Re: 605 Chelsea Street Notice of Intent – Supplemental Information

This Supplemental Information to the Notice of Intent (NOI) for the project at 605 Chelsea Street (the "Project Site") responds to the request for additional information received from the Boston Conservation Commission (the "Commission") during the public hearing held on August 17, 2022.

605 CHELSEA STREET MARINE UPGRADES CARGO VENTURES EAST BOSTON, MA

DRAWING NO:

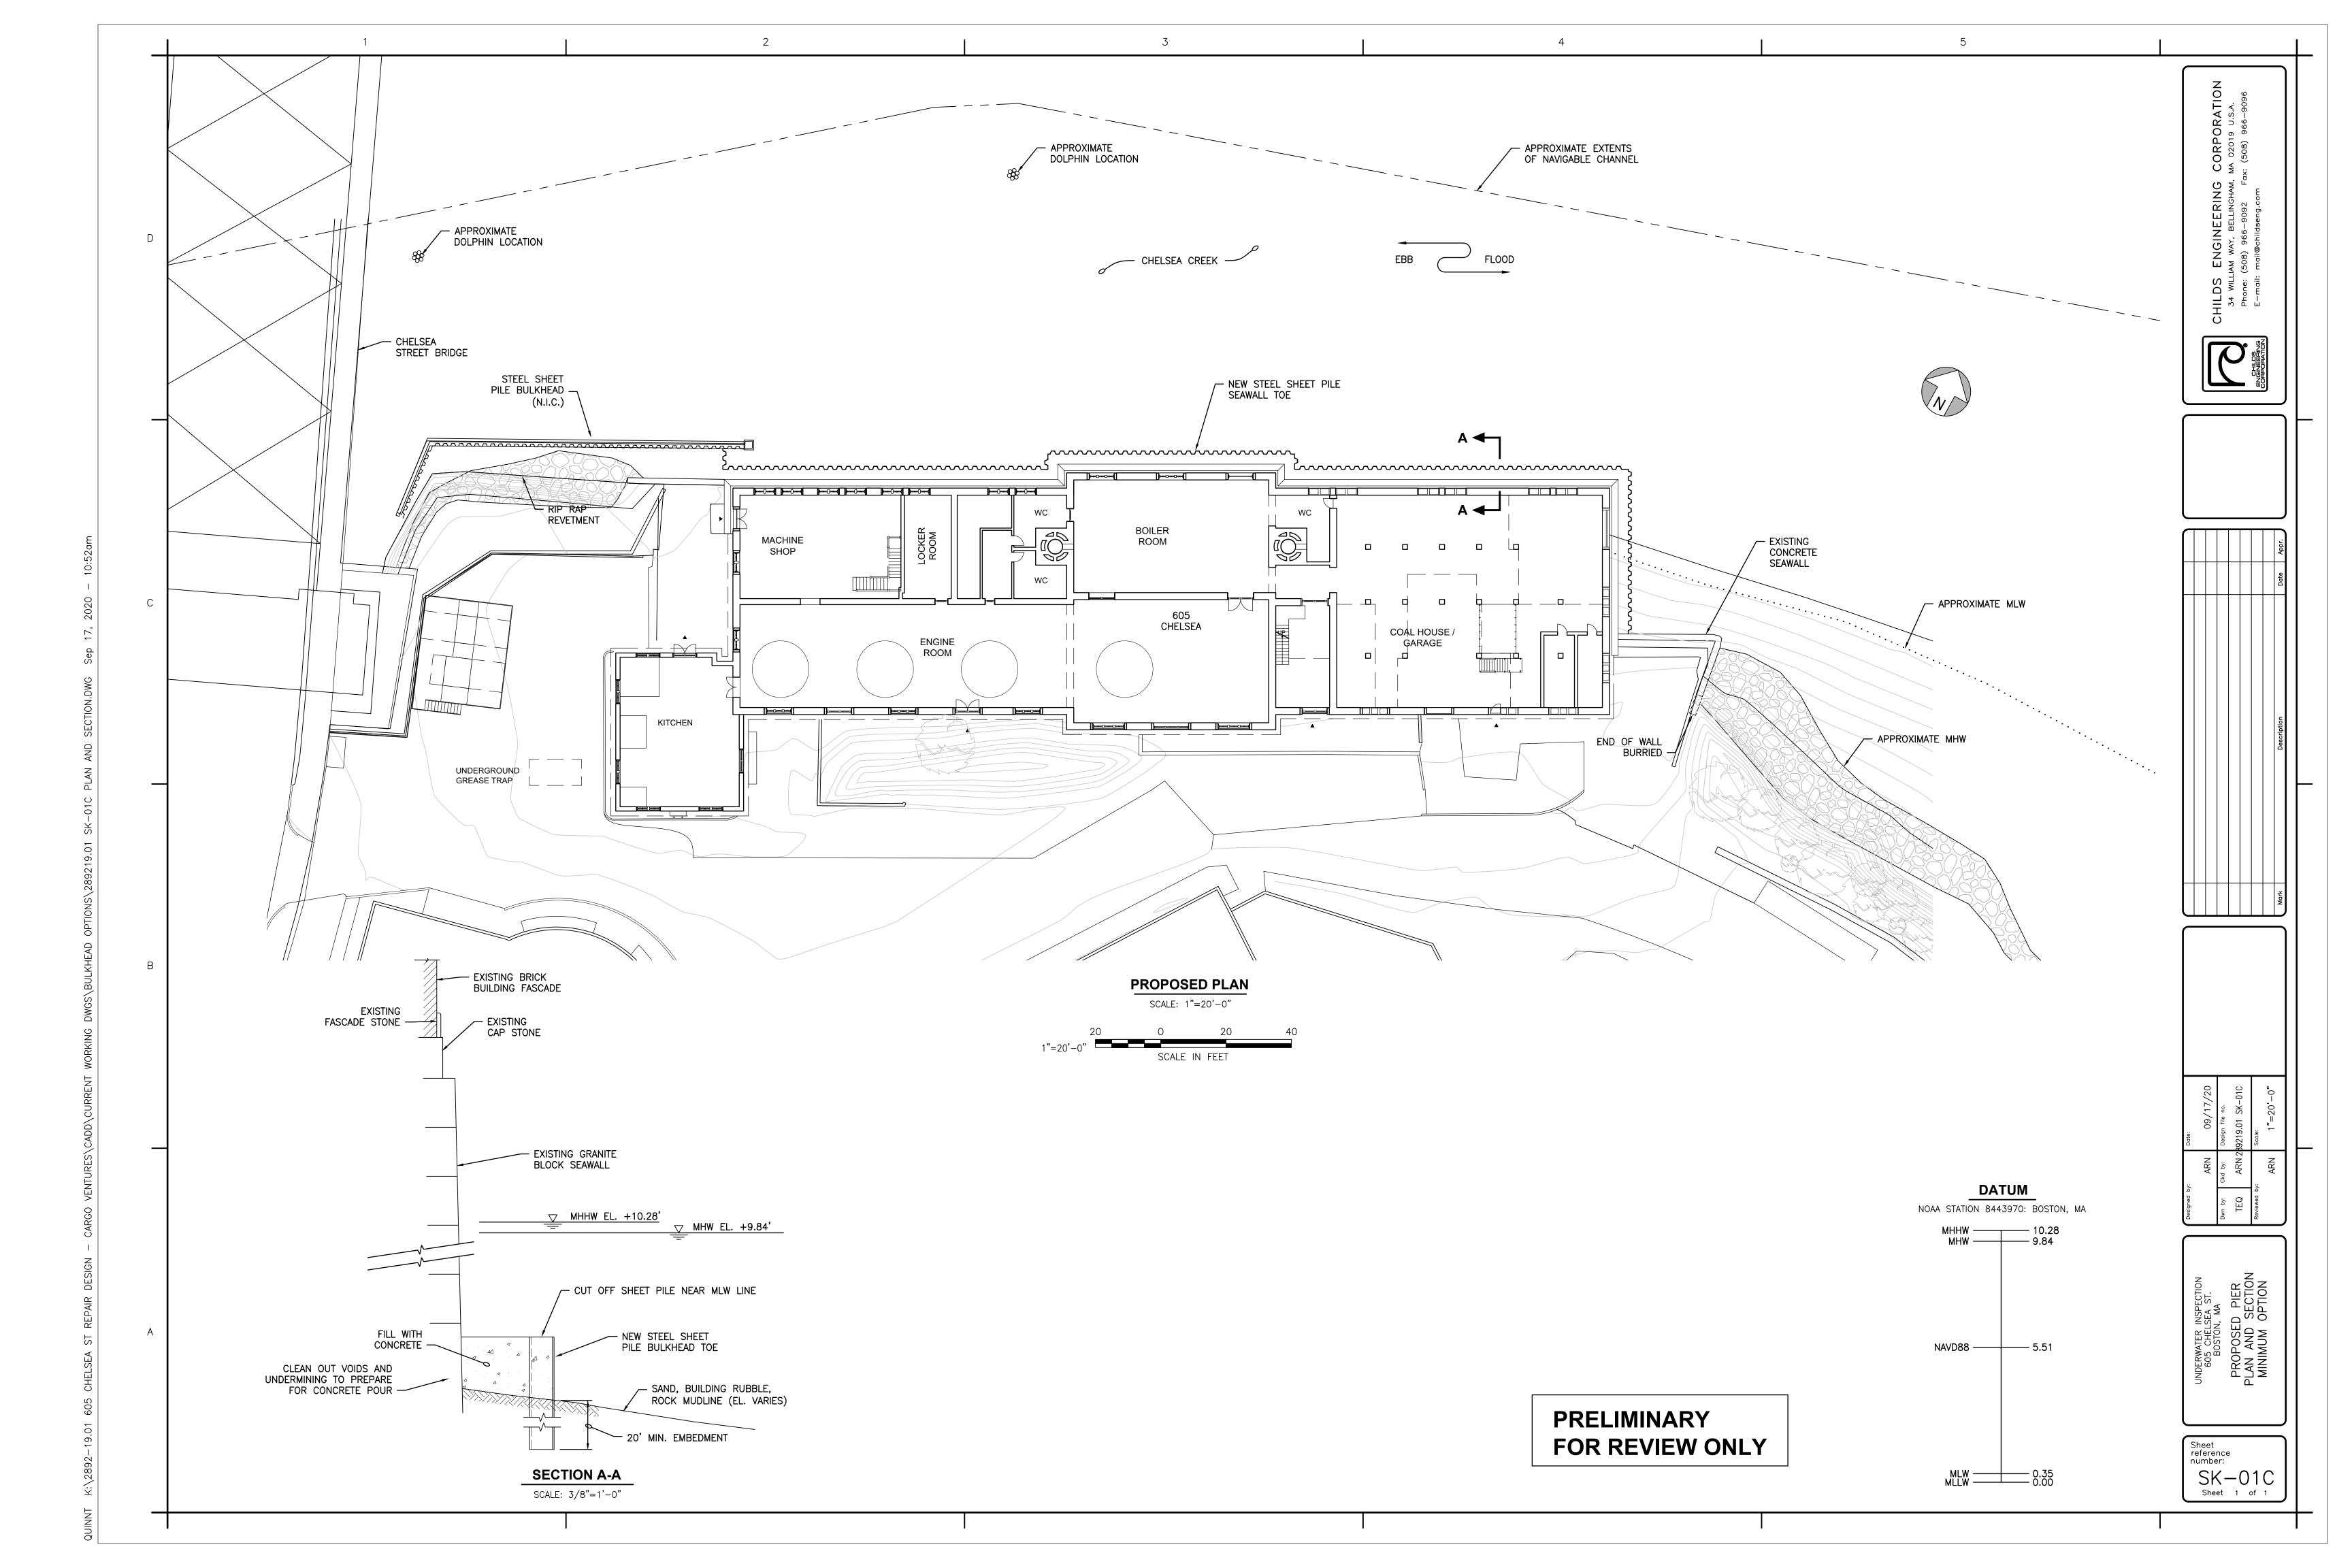
The enclosed Seawall Repair Options Plan Set outlines the three options considered:

Option A: Replace the existing seawall with a new steel sheet pile bulkhead and tieback system. This option assumes that additional load carry capabilities are required due to significant changes in the assumed loads carried by the building. This method requires that a tieback system be installed to provide lateral support of the seawall. The tieback system would require that grouted earth anchors or tierods connecting to an inshore deadman be installed roughly every 6 feet on center along the length of the seawall. The sheet pile would extend to roughly the top of the existing seawall and the annular space between the sheet pile and seawall will be filled with concrete. This method was determined to not be required as there were no significant changes to the loading capabilities of the building from the perspective

- of the seawall. It was also determined that this method would need to overcome significant construction challenges such as the installation of earth anchor or a deadman as well as installing the tierods through the existing stone seawall.

- Option B: This is the option currently outline for the proposed project. This option includes a sheet pile bulkhead installed in front of the existing seawall after all voids are filled with concrete or grout. The annular space between the sheet pile and seawall are to be filled with concrete. This option assumes the existing seawall will maintain original design intents and load carrying capabilities with no significant changes. The sheet pile and concrete will encase the existing seawall and protect from future deterioration and mudline reductions allowing it to continue to function.

- Option C: This option was recommended as the minimum repair effort that should be undertaken to fix the seawall underminings. It requires that a steel sheet pile bulkhead be installed in front of the existing seawall and terminated at MLW. The annular space between the seawall and sheet pile is filled with concrete. The existing seawall from MLW to the top of the wall would remain exposed. The exposed seawall would require additional repairs to the deteriorated section or areas of voids. It was determined that this method is not preferable because the overall repair lifespan would be less than Option B.

EXISTING WETLAND RESOURCES

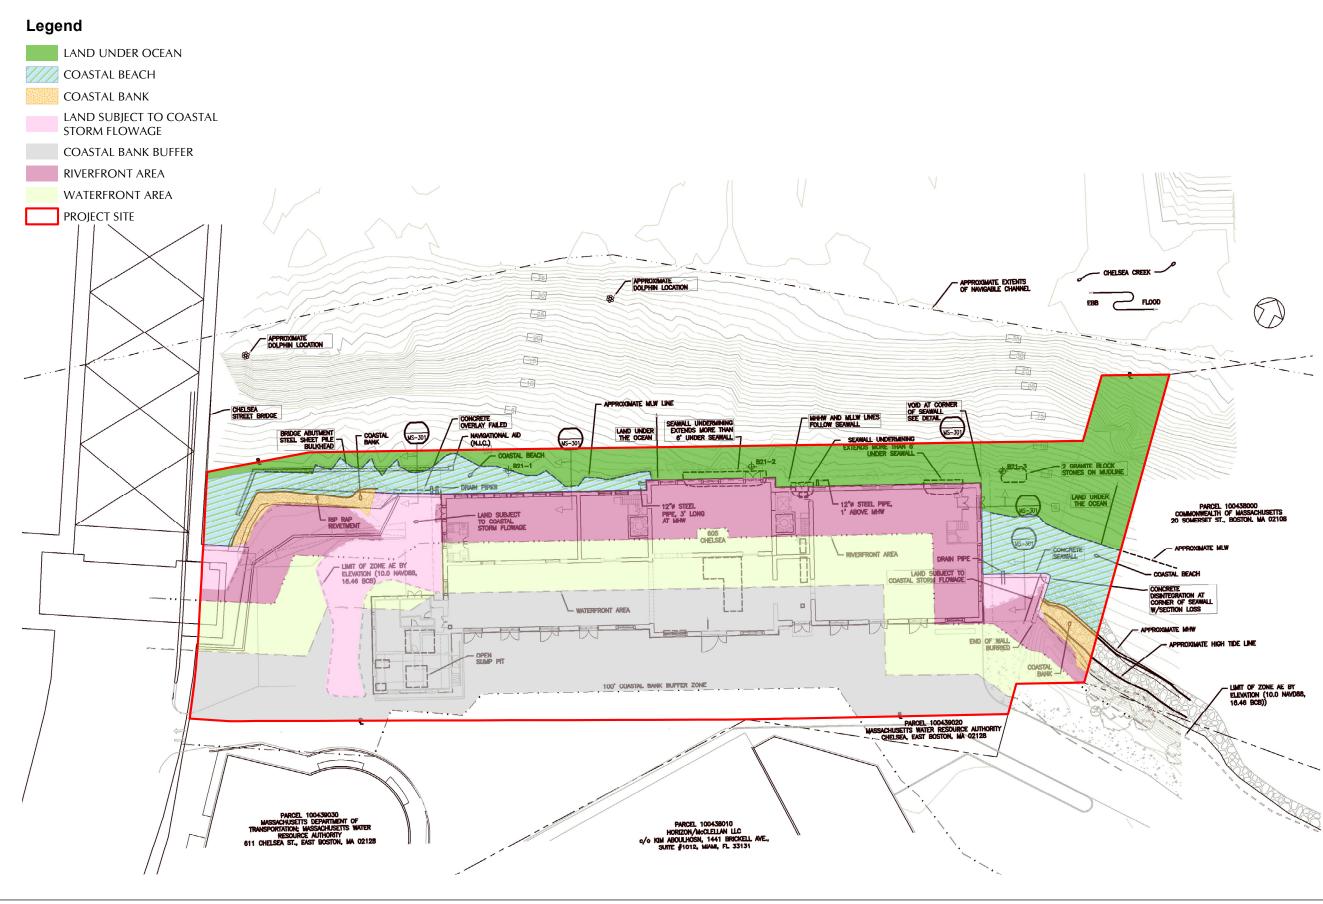
9.0 Existing Conditions Wetland Resource Area Map

The NOI contained a color-coded resource area map for proposed conditions. Please find enclosed a similar map, Existing Wetland Resources.

PHOTOGRAPHS OF EXISTING TREES

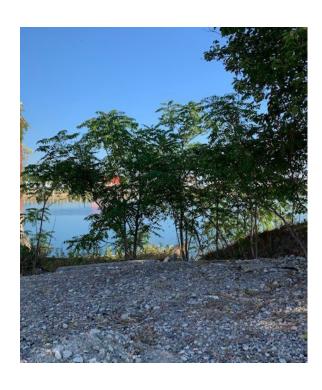
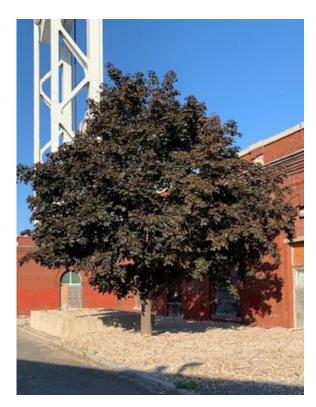
The Project's landscape architect conducted a site visit on August 25 and identified two existing trees of significance on the property. Directly in front of the building is a 14-inch diameter at breast height (DBH) Crimson King Norway Maple. To the east of the building is a multi-stem Black Mulberry Tree. The main trunk of the mulberry tree 14-inch DBH and the secondary trunks range from 2.5-inch DBH to 6-inch DBH. In addition, there are a

handful of small < 2-inch DBH Ailanthus trees on the east side of the Project Site. See the enclosed Photographs of Existing Trees.

The Project proposes removal of the Crimson King Norway Maple and Ailanthus trees and to incorporate three 3-inch caliper trees in the pervious planting area along Chelsea Street between the walkway and parking. Proposed tree species will be cross referenced between the USDA Plant Database and Vascular Plants of Massachusetts checklist.
